M6 Stage 1 Project Team
Transport for NSW
PO Box 7261
Alexandria NSW 2015

Re: M6 Stage 1 draft Urban Design Landscape Plan

This submission will focus on the active transport elements with a particular focus on Appendix B of the UDLP plan, the Pedestrian and Cycle Implementation Plan (PCIP).

Figure 1: Typical cross section of the separated walking and cycling paths to be constructed for the ATC, showing the 1m median and shoulders (Source: TfNSW)

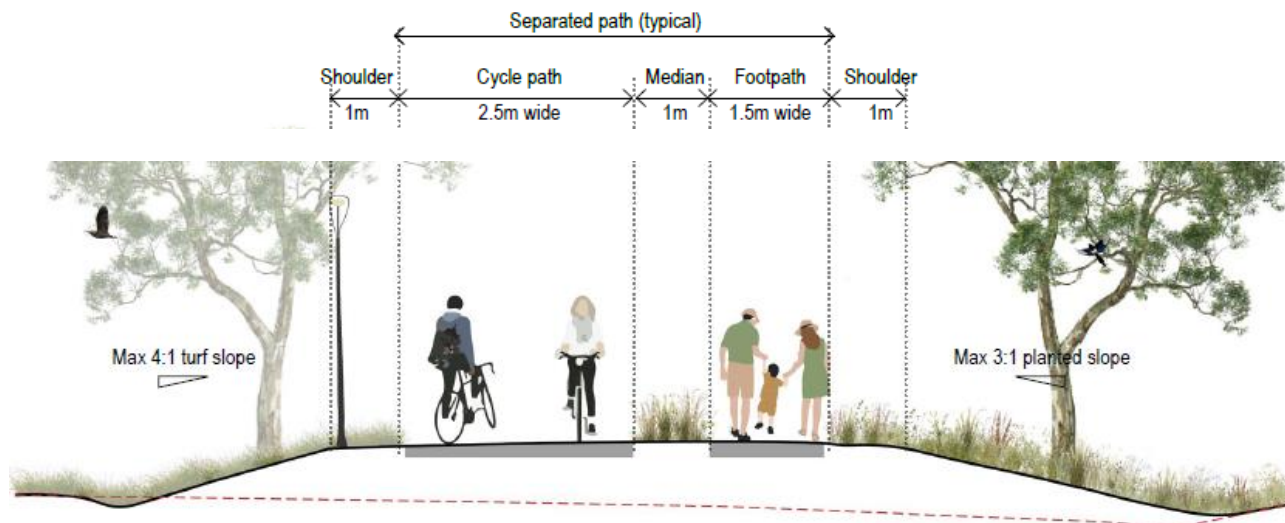
Large sections of ATC will be constructed as generous wide separated paths (Figure 1). It is clear that the project aims to accommodate both recreational bike riders as well as commuters passing through at speed, and minimise conflict with people walking.

The paths will be future-proofed by incorporating wide 1m shoulders and medians, ensuring space for expansion as user volumes grow – as they undoubtedly will population and appetite for active transport surges.

Figure 4: Plan of the proposed ATC showing areas of concern (Source: TfNSW/ Bicycle NSW)

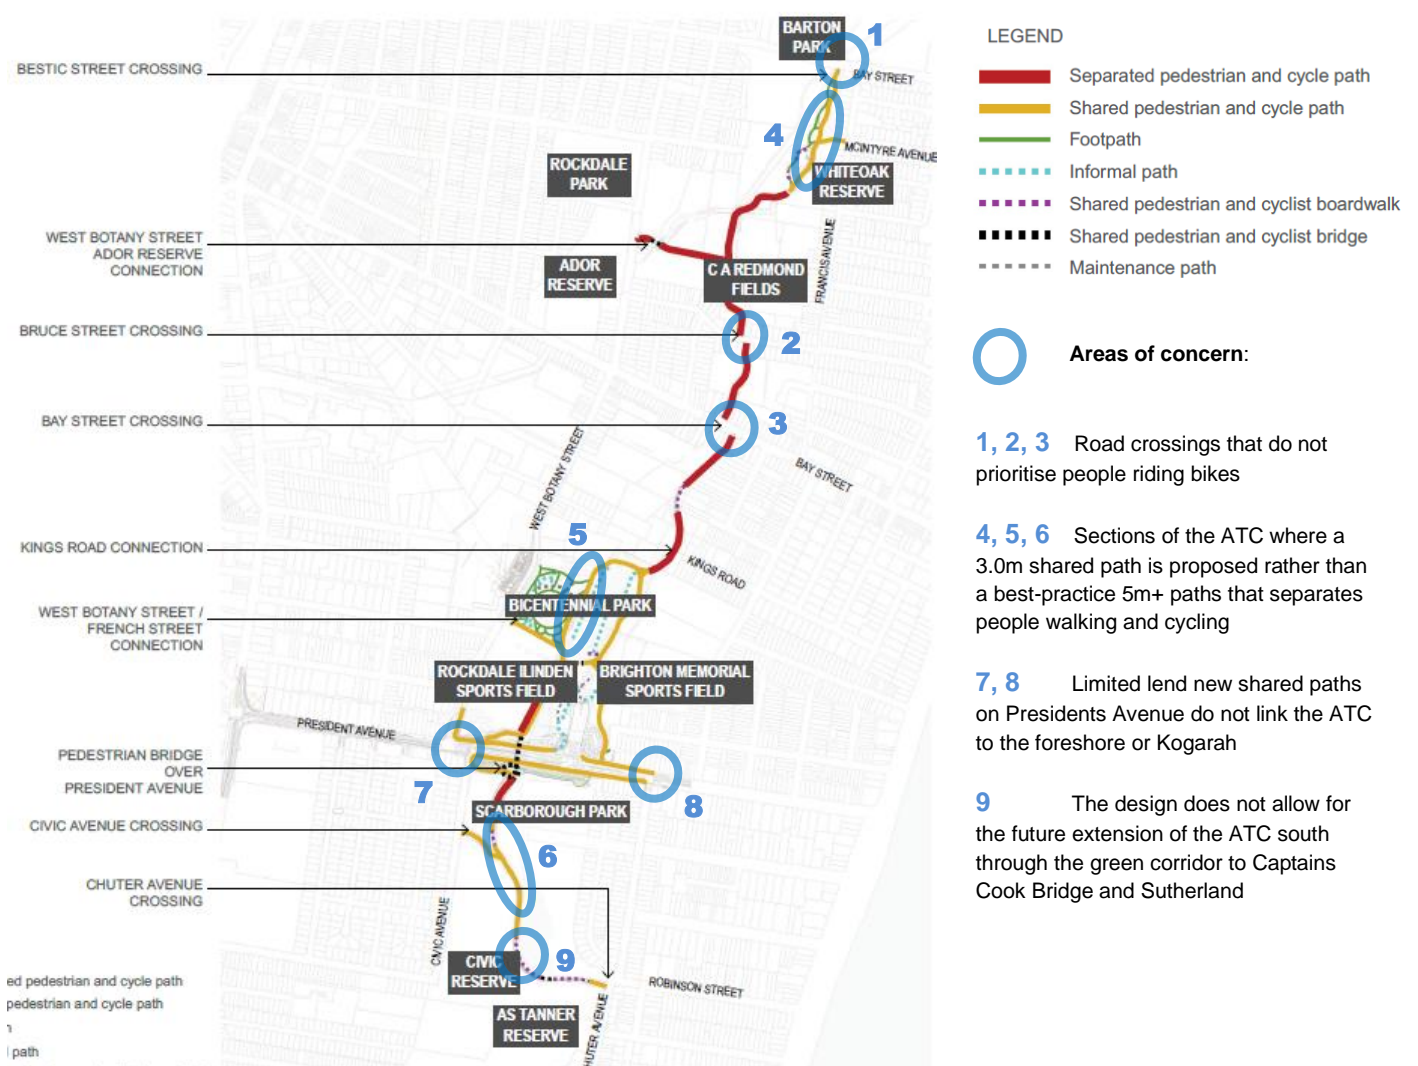
- The generous separated paths are not planned for the full length of the ATC. 3.0m shared paths are proposed for several sections (marked in yellow on the plan in Figure 4). This is disappointing. There is likely to be conflict between faster and slower cyclists, and between cyclists and pedestrians, and this will worsen as population increases.
- Plans for the ATC do not currently incorporate a stub to ensure easy future connections to the south towards Captain Cook Bridge to complete an important Green Grid project. We assume that Stage 2 of the motorway will follow in the near future.

- Despite promise to “limit discontinuities” there are several road crossings where cyclists are expected to dismount. The ATC is broken at both Bay Steet and Bruce Street. This is not acceptable for an important regional cycling route.

- Traffic calming is planned for O’Connell Street/Chuter Avenue and Civic Avenue/Marshall Street. However, there is no wider ambition to lower speed limits and reduce traffic volumes on residential streets and village centres throughout the project footprint to create a network of local cycling facilities. The convenience of drivers is not being impacted.

- The new shared paths to either side of President Avenue only extend from Civic Avenue to O’Connell Street – not to the beach or town centres. The ATC doesn’t maximise opportunities to feed into a local cycling network. This is despite the UDLP stating: “Our aim is to connect people and places across suburbs with new footpaths and cycleways”.

The sections of shown in red on Figure 4 promise to deliver a world-class active facility. A wide path, with a landscaped buffer or clear delineation to separate people walking and cycling, should be extended through as much of the corridor as possible.

This includes the sections from Bestic Street through Whiteoak Reserve to the proposed separated facilities starting near the CA Redmond Fields, the western half of the path loop proposed in Bicentennial Park and the path between the southern end of the President Avenue bridge and intersection with the future path heading south. The locations are marked on the map as 4, 5, and 6 in Figure 4.

Figure 5: Extract from the new Strategic Cycleway Corridors network for the Eastern Harbour City (Source: TfNSW)

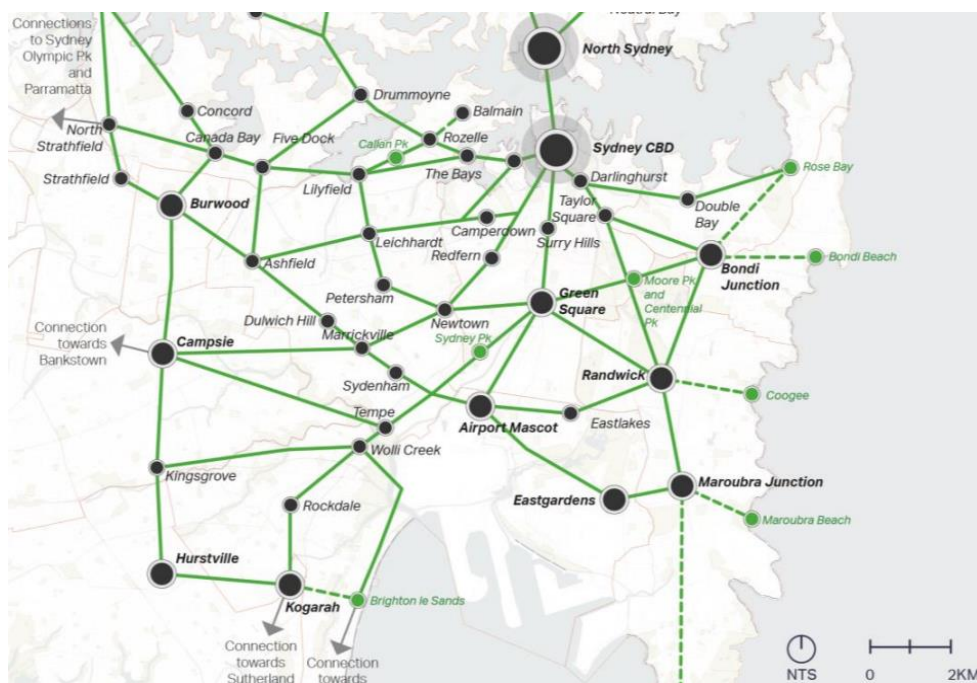
The Eastern Harbour City Strategic Cycleway Corridorsⁱⁱⁱ was released under the direction of Minister Stokes in April 2022. 30 strategic corridors have been identified for eastern Sydney, making up approximately 250km of cycle network (Figure 5). The corridors will connect key centres and form the backbone of the Principal Bicycle Network. Exact routes will be subject to detailed design and collaboration with councils and the community. The M6 Stage 1 ATC is a crucial opportunity to complete the Brighton-le-Sands to Tempe corridor.

Figure 6:
Extract from the Green Grid showing project opportunities in the Bayside area (Source: Tyrrell Studio / NSW Government Architect)

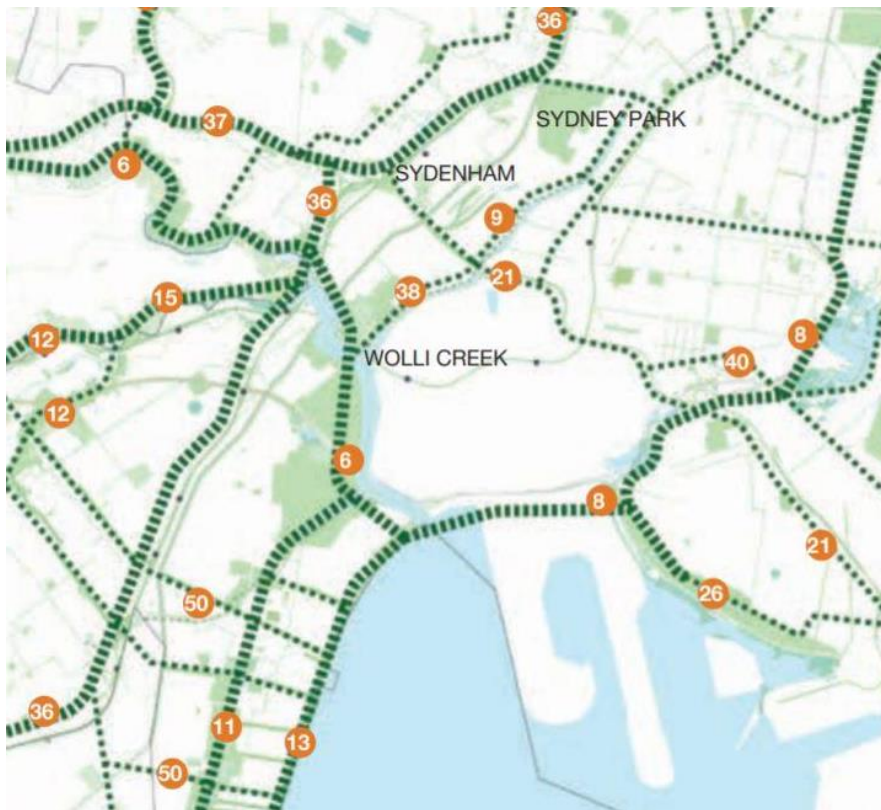
The Sydney Green Grid^{iv}, developed by the NSW Government Architect in 2017 and reflected in the district and region plans, proposes an interconnecting network of open spaces that support walking and cycling. The Green Grid creates important links between activity centres and support active recreation. The project opportunities for the Bayside area are shown in the extract from the Green Grid in Figure 6. The long-term vision of extending the Cooks River Open Space Corridor to Kyeemagh and developing the Rockdale Wetlands Open Space Corridor is established by the Green Grid.

Figure 7: Sydney Gateway active transport network opportunity map (Source: TfNSW)

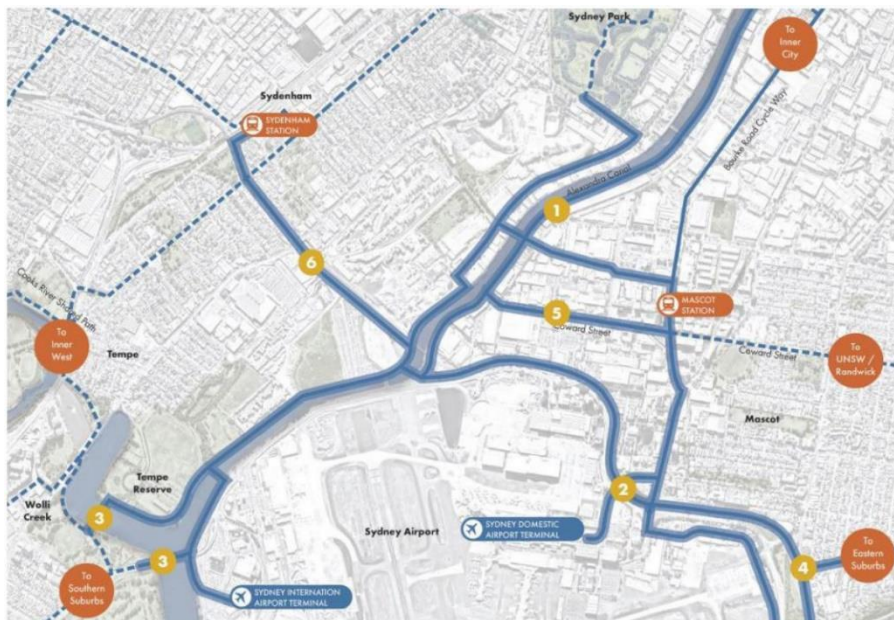
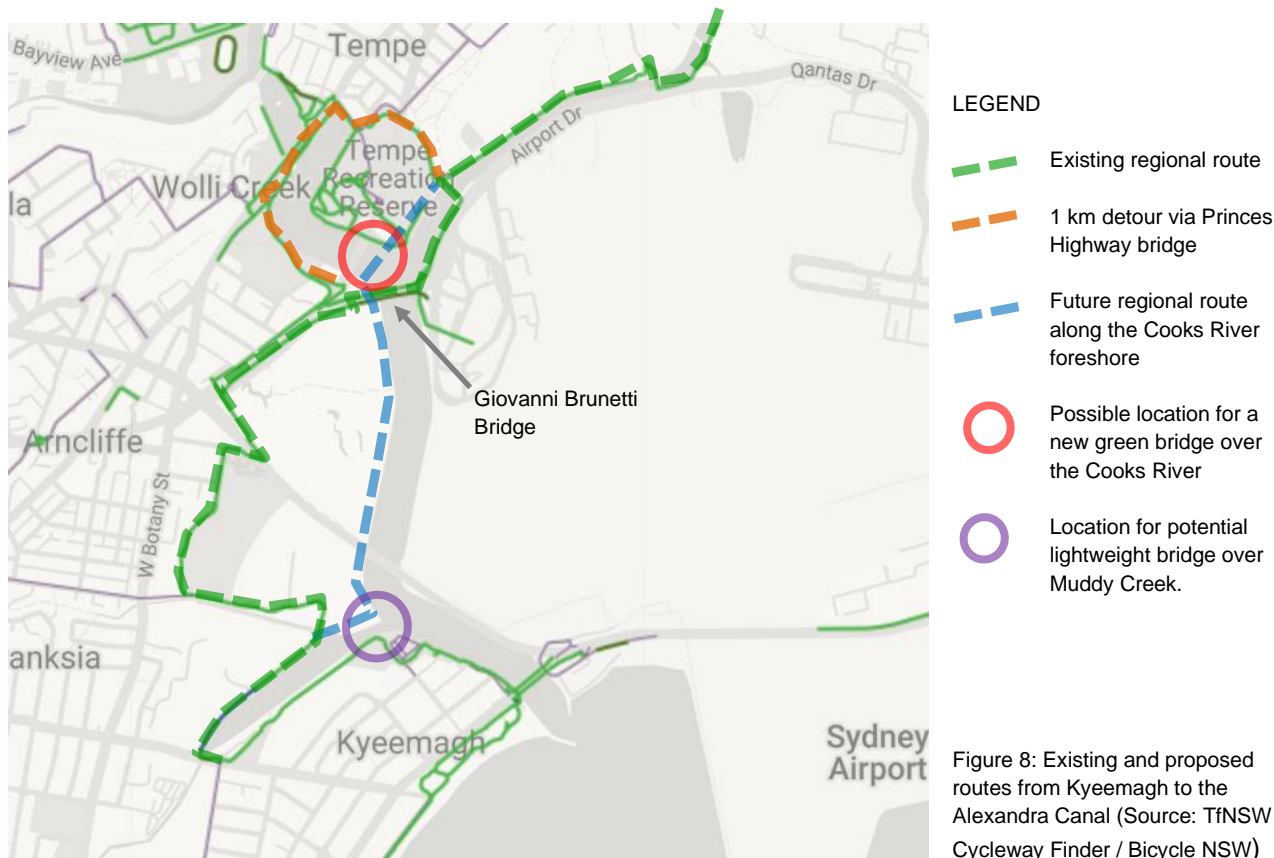
The Sydney Gateway Active Transport Strategy^v was finalised at the end of 2022. Several priority connections to the airport (Figure 7) are discussed and analysed. Two options are put forward for locating a new Cooks River bridge for pedestrians and bike riders.

We join with other advocates to call for the critical element of this regional connection, a new green walking and cycling bridge over the Cooks River, to be included in the scope of the project.
